Study on cycle modification

~ Reflect validation test 1 result ~

Prepared by Japan

10th DHC sub-group meeting
under GRPE/WLTP informal group
11-12 October 2011
Brussels, Belgium

1.2. Potential area need to be modified

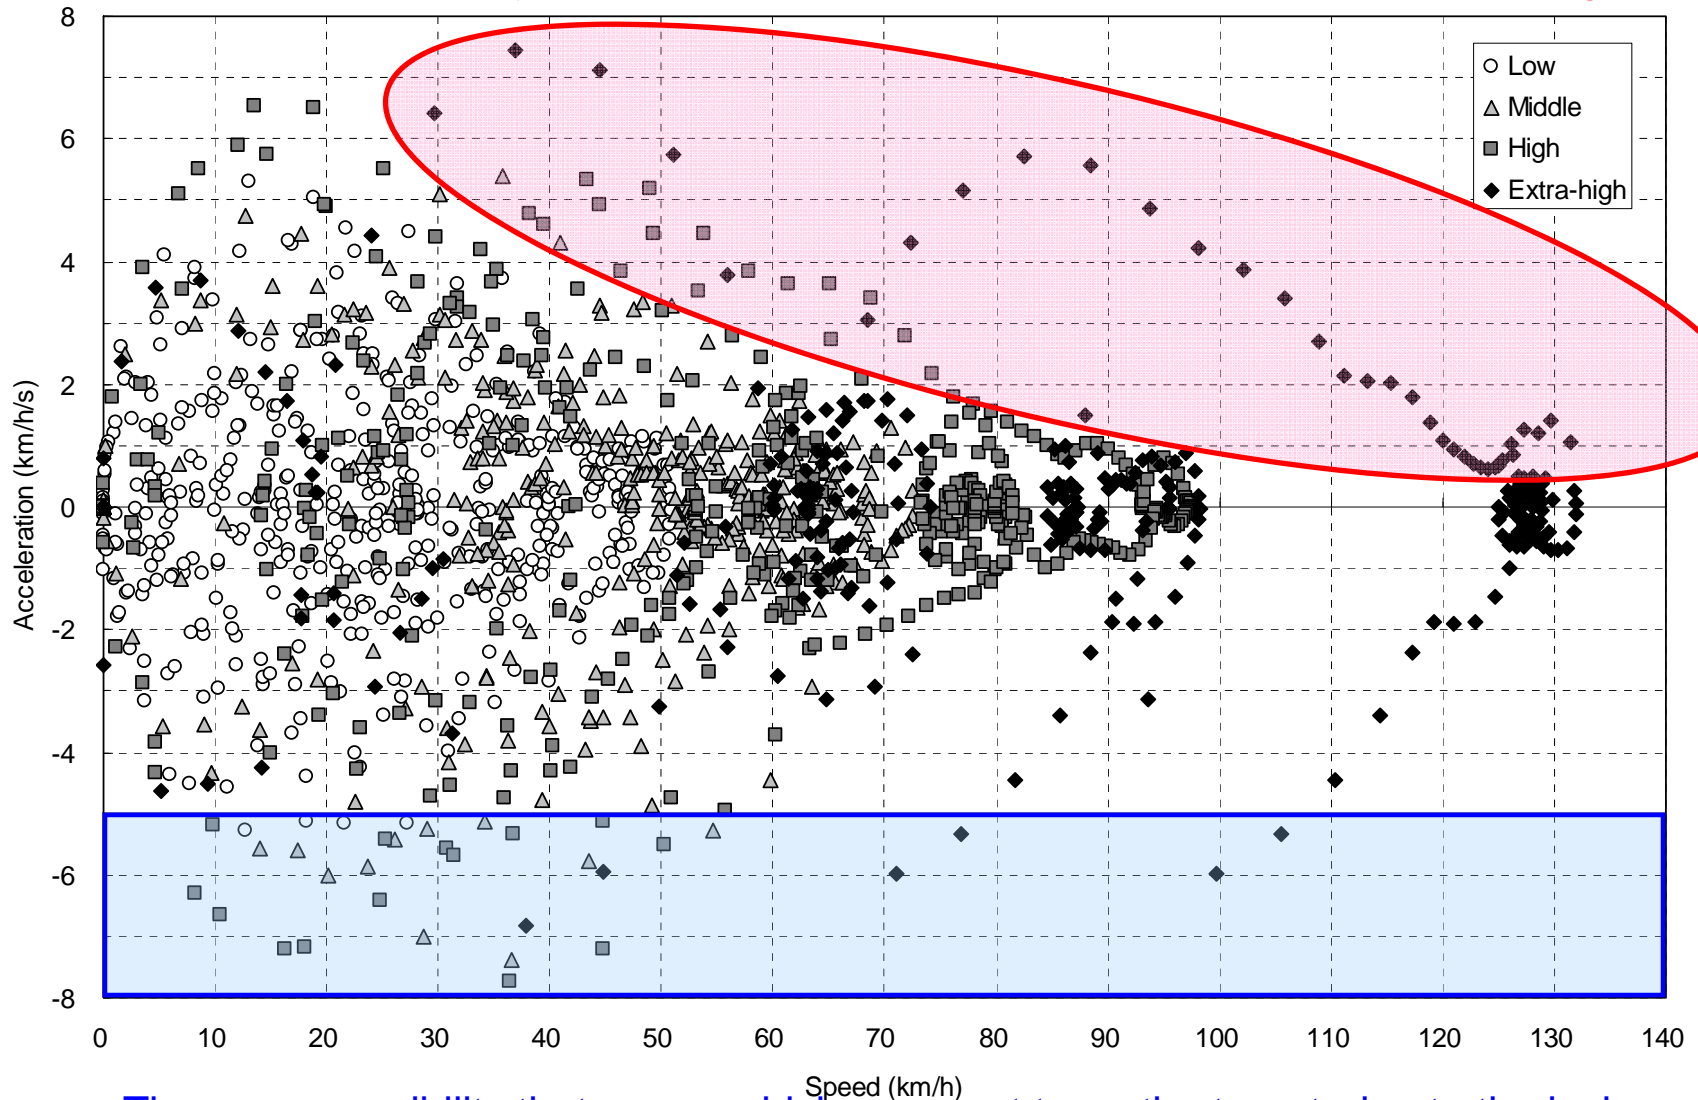
There are possibility that low/middle powered vehicles can not follow the target

There are possibility that some vehicles can not trace the target, due to tire lock, shortage of brake power of rear wheel.

2.2. Proposal for modification parts

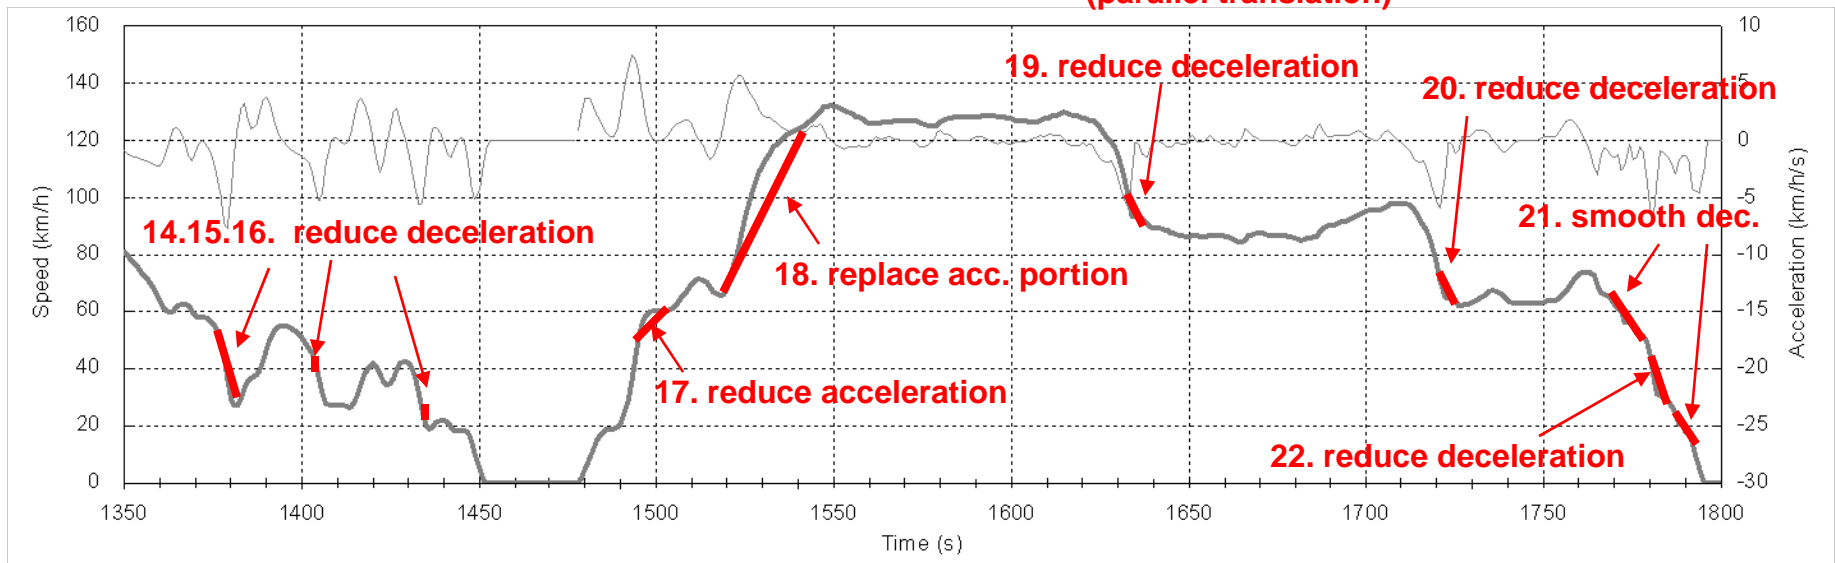
8. reduce deceleration

12. increase vehicle speed (parallel translation)

6.1.1. Review acceleration for MIDDLE phase

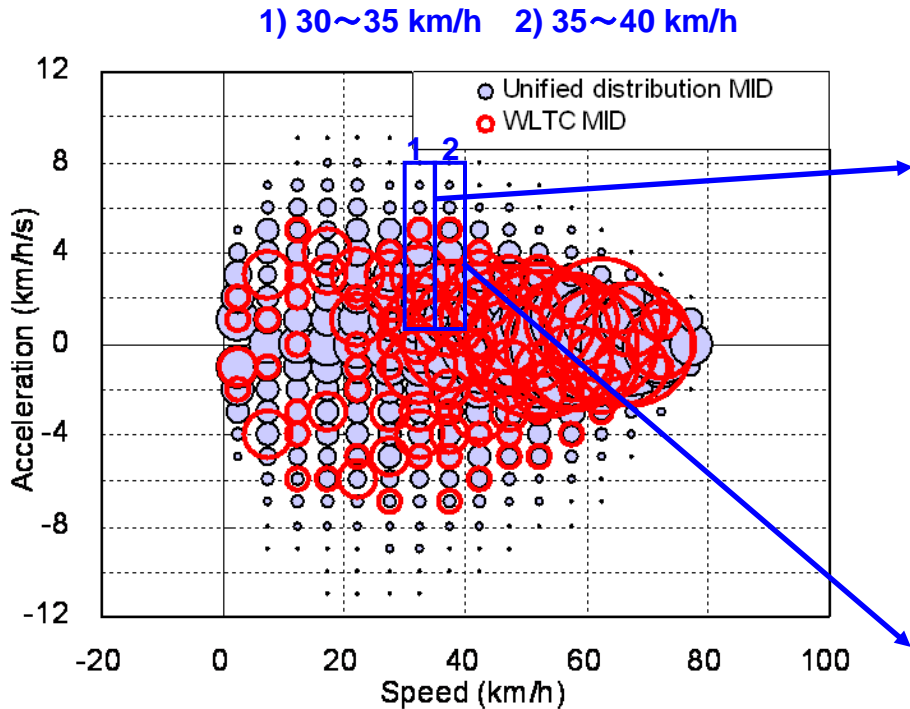
Because acceleration in middle phase keep in 95percentiles, it is not necessary to modify the acceleration parts in middle phase

6.1.3. Review acceleration for HIGH phase - 2

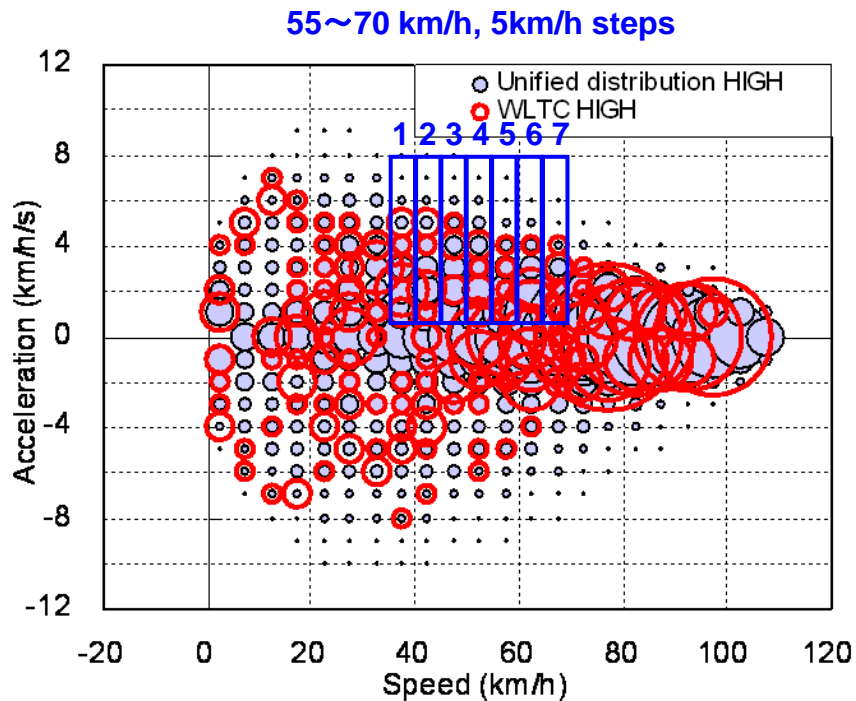
In HIGH phase, acceleration exceed 95 percentiles in the range of 60 to 70 km/h, Therefore it is necessary to reduce acceleration

6.1.6. Review acceleration for Ex-HIGH phase-3

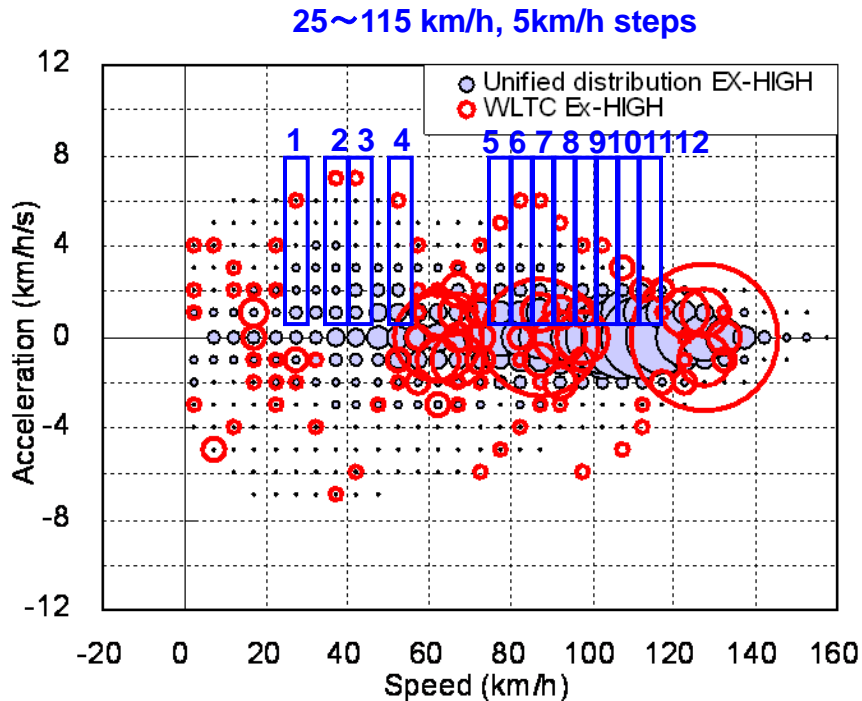
In Ex-HIGH phase, acceleration exceed 95 percentiles in the range of 35 to 55 km/h and 75 to 115 km/h. Therefore it is necessary to reduce acceleration

6.2.2. Ex-HIGH (65-130 km/h)

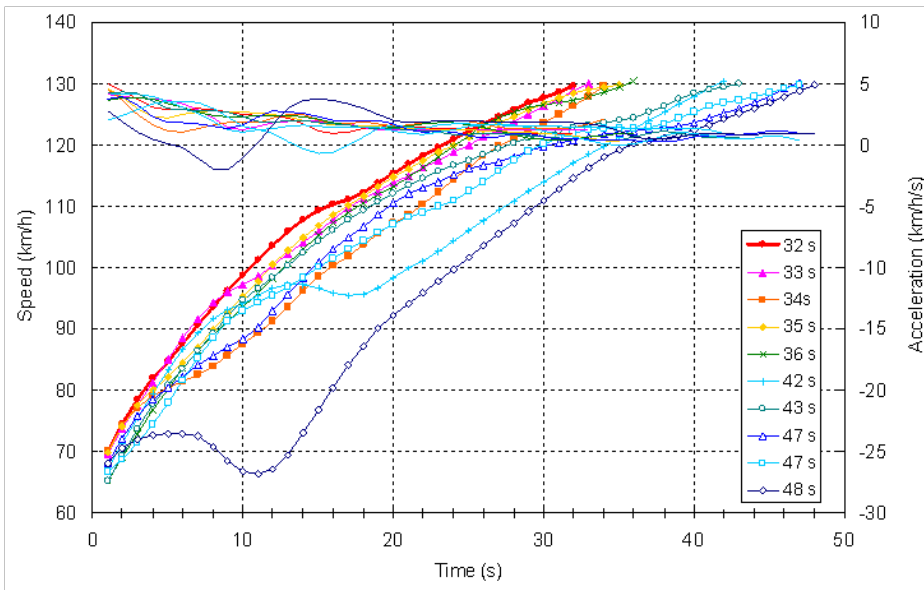
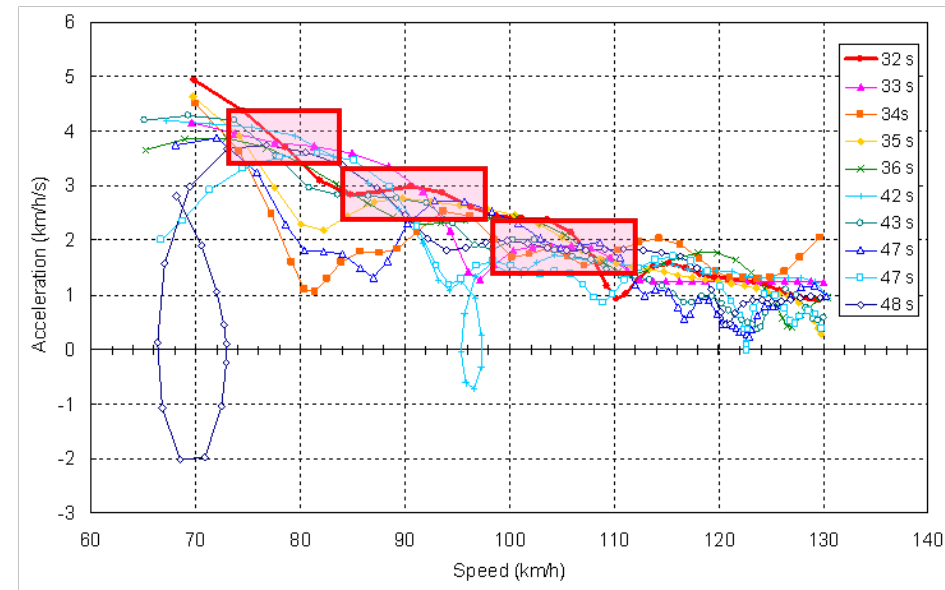
- Search acceleration portion which meet the above criteria from in-use database
- Select the shortest / highest acceleration one

65-130km/hまでの区間を32秒で到達する加速データを選択
